ADDENDUM NO. 3

SCC Mohr Hall Replacement

LRCCD BID NO. 18025

LRCCD Sacramento City College Mohr Hall Replacement Building
 Los Rios Community College District
 LRCCD Bid No: 18025

- 1) PROVIDE BUTTERFLY VALVES WITH LONG TEE EXTENSION WITHIN PRECAST VALVE BOXES.
- 2) PROVIDE LOW VOLTAGE CONTROL CONDUIT BY BMS CONTRACTOR FROM EQUIPMENT YARD TO BUILDING. RUN CONDUIT WITHIN HYDRONIC PIPING TRENCH. COORDINATE TRENCHING AND BACKFILL W/ BMS CONTRACTOR.

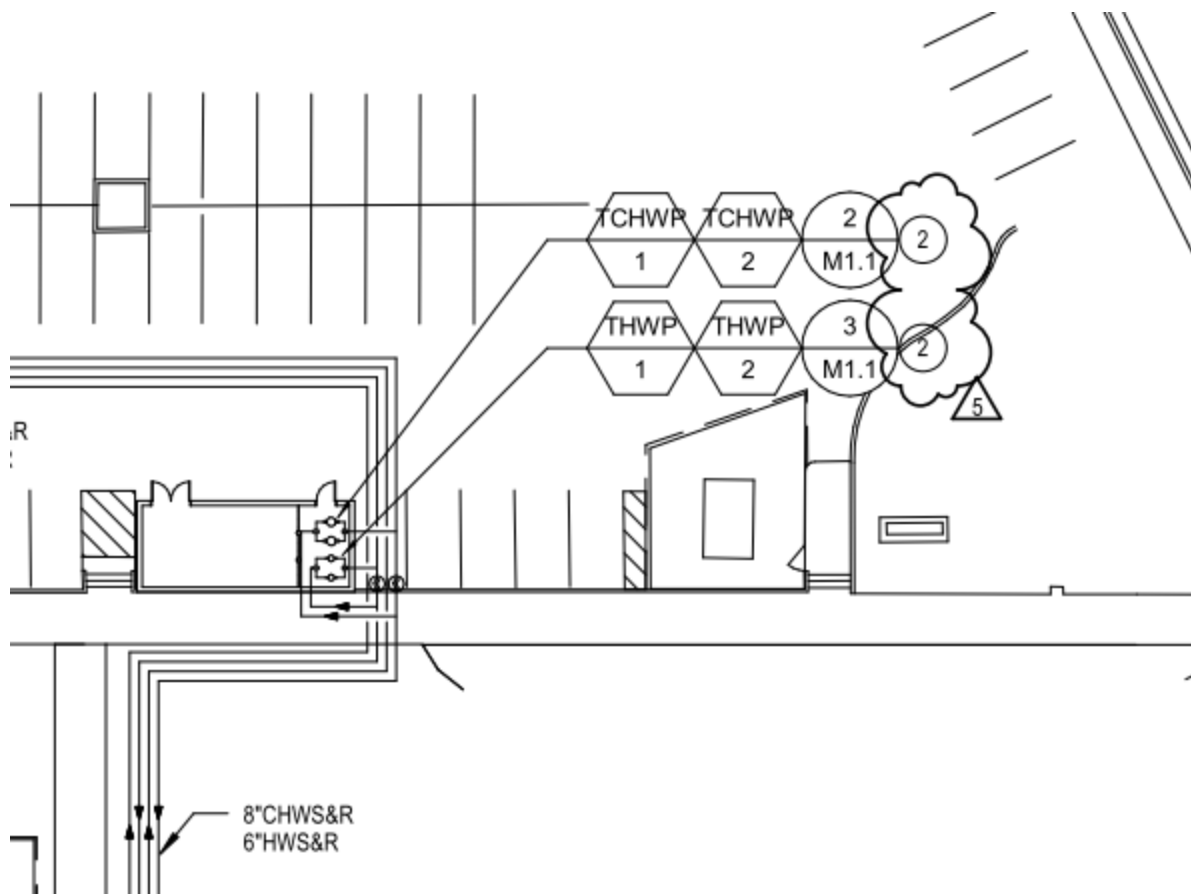
Page M1.1: TCWP1, TCHWP2, THWP1, and THWP2 require controls communication wiring run from the Equipment Enclosure (located at the Mohr Hall parking lot) to Lillard Hall. Please confirm if the Building Management Controls System provider may utilize the plumbing trench shown on M1.1 to run (1) 1” BMCS low voltage conduit? If yes – please consider adding a note to page M1.1 “Coordinate trench backfill with BMCS provider.

Answer: Controls contractor can run their conduit adjacent to the hydronic trench. See revision on 1/M1.1

SHEET NOTES:

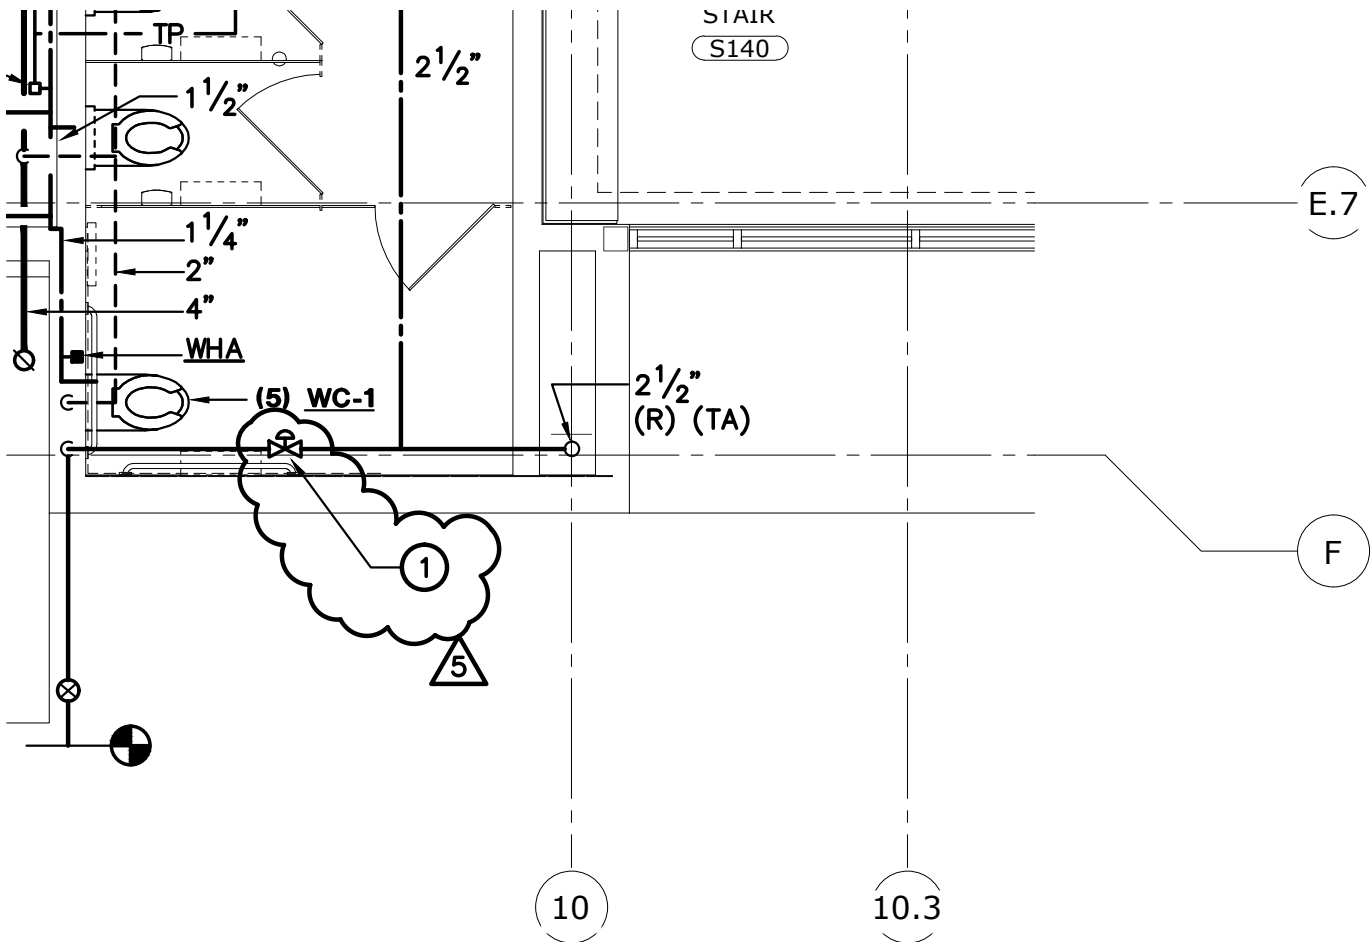
Recent LRCCD projects required incorporation of building Water and Gas Meters into the BMCS (e.g. Davis Center Phase II and ARC STEM). The bid drawings for this project do not appear to have this requirement – please confirm.

Answer: On the incoming 2-1/2” domestic cold water line, provide Onicon series F3000 meter with carbon steel outer body, 304 stainless steel internal flow tube and class 150 flanges. Install per manufacturer’s requirements. Tie into BMS control system. There is no gas in the Mohr Hall replacement building. See plan revision note on 1/P4.1

- ① PROVIDE "ONICON" SERIES F3000 METER W/ CARBON STEEL OUTER BODY, 304 STAINLESS STEEL INTERNAL FLOW TUBE AND CLASS 150 FLANGES. INSTALL PER MANUF'S REQUIREMENTS AND TIE INTO BMS SYSTEM.

A ELECTRICAL & MECHANICAL ROOMS - FIRST FLOOR
SCALE: 1/4" = 1'-0"

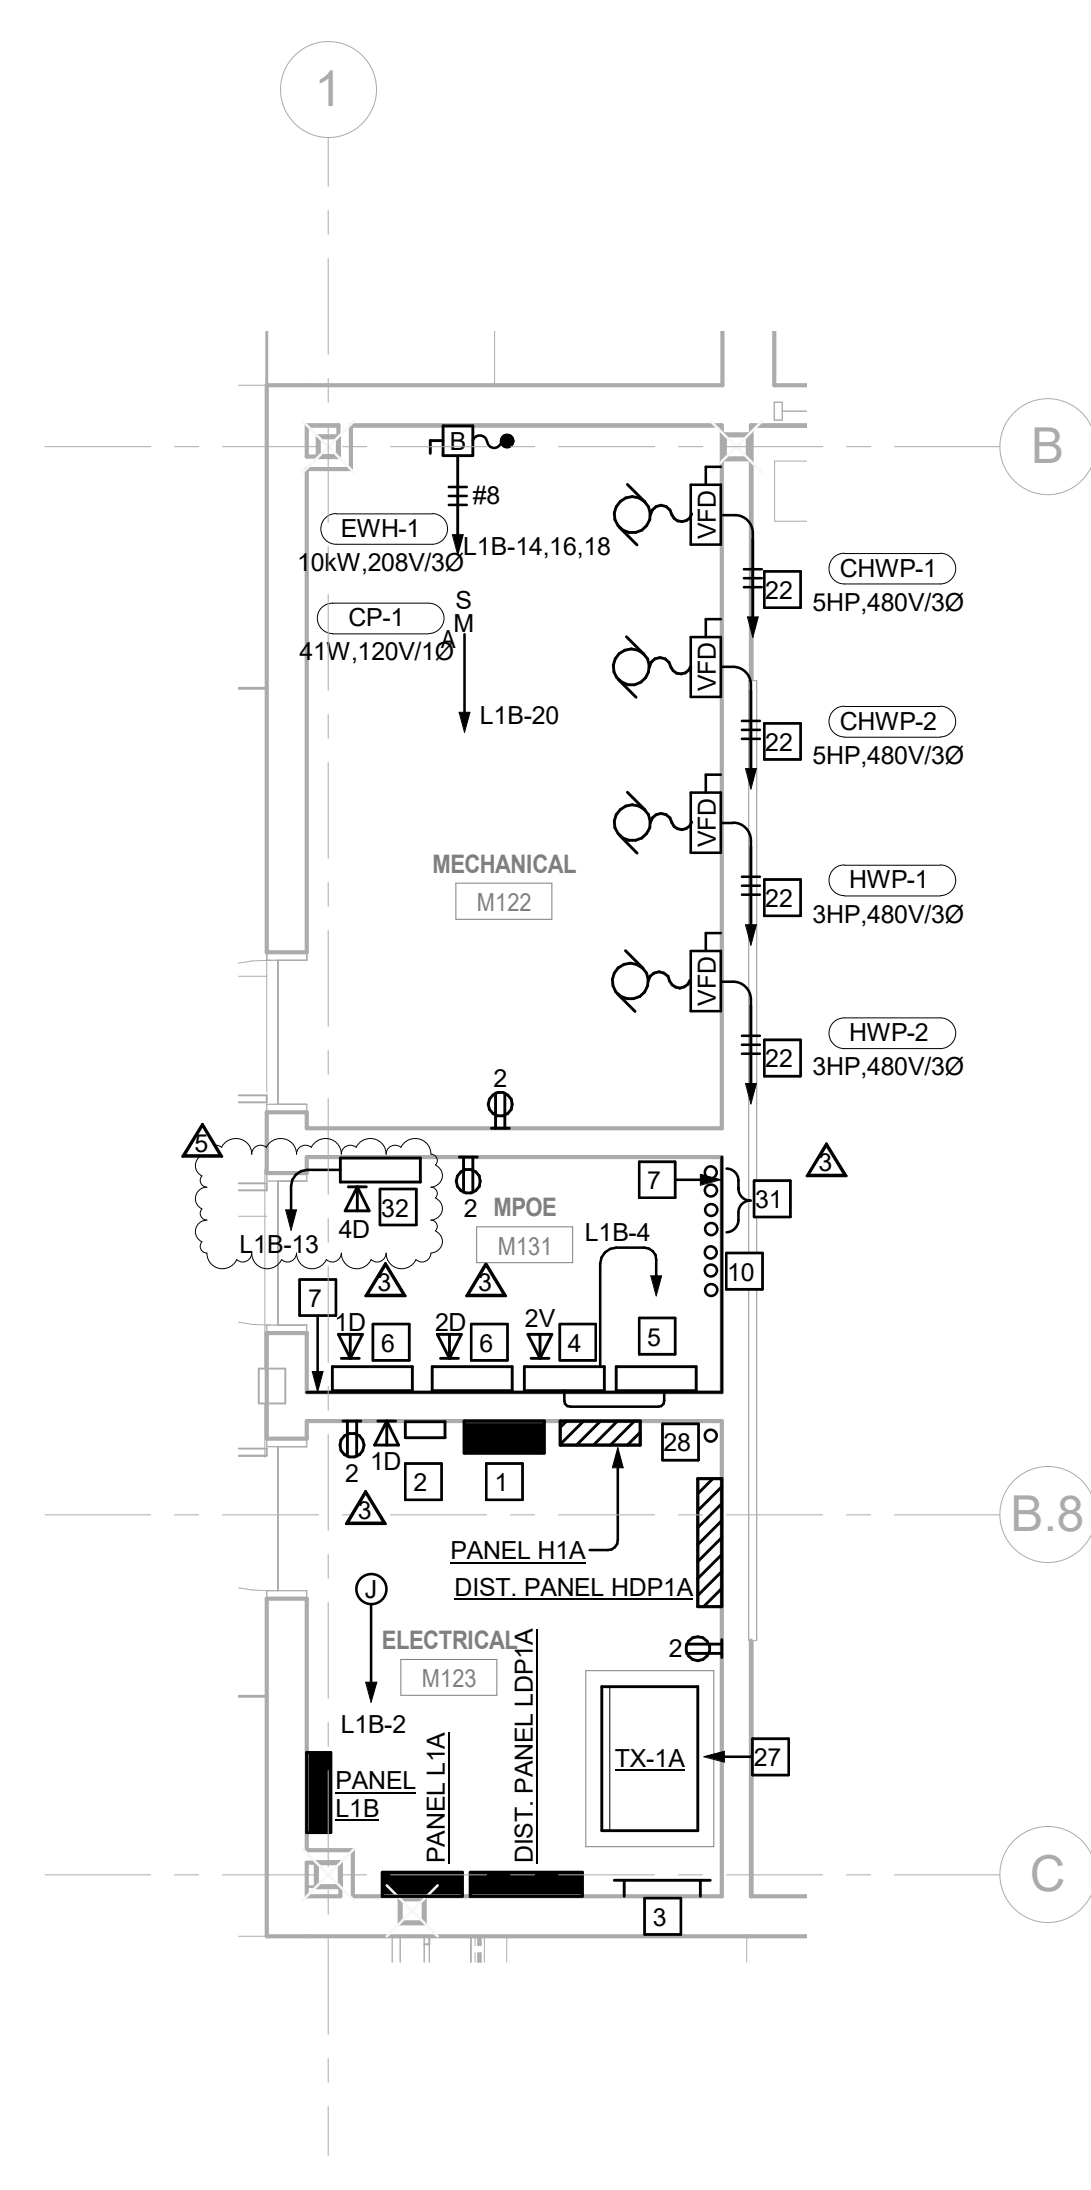
Question: Page E6.01 Detail A does not appear to require Division 26 to provide 120V for BMCS Temperature Control Panel – please consider revising the detail A to add the 120V TCP requirement.

Answer: Provide 120V circuit L1B-13 and hardwired connection to Temperature Control Panel located in room M131. Provide four network drops from M219 to the TCP. Coordinate requirements with the controls contractor. See revised electrical drawing E6.01.

- 31 PROVIDE 4-4" SLEEVES BETWEEN FLOORS, PROVIDE UL LISTED FIRESTOPPING AS REQUIRED.
- 32 PROVIDE 120V CIRCUIT L1B-13 AND HARDWIRED CONNECTION TO TEMPERATURE CONTROL PANEL LOCATED IN ROOM M131. PROVIDE FOUR NETWORK DROPS FROM M219 TO THE TCP. COORDINATE REQUIREMENTS WITH THE CONTROLS CONTRACTOR.
